Technical Note Glider Ka 6 E L - 205

No. 17 LTA Nr. 68/109

Suspension of the thermosbottles beow the baggage

compartment.

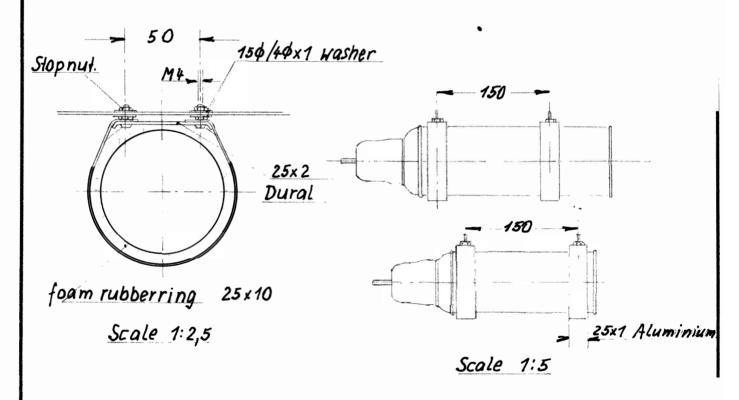
There is the suspicion, that a bottle got loose and

blocked the controls.

Remove the bottles and cut off the existing screws. Place new clamps over the bottle and install rubber ring in between. Adjust correct distance of the clamps (see sketch). Drill holes for the attaching screws in the plywood bottom floor from the inside of luggage compartment. Any existing equipment

should be removed before.

Install bottles using 15 mm Ø washers on each side

of floor bottom. Reconnect the bottles in the

correct sense to instrument lines.
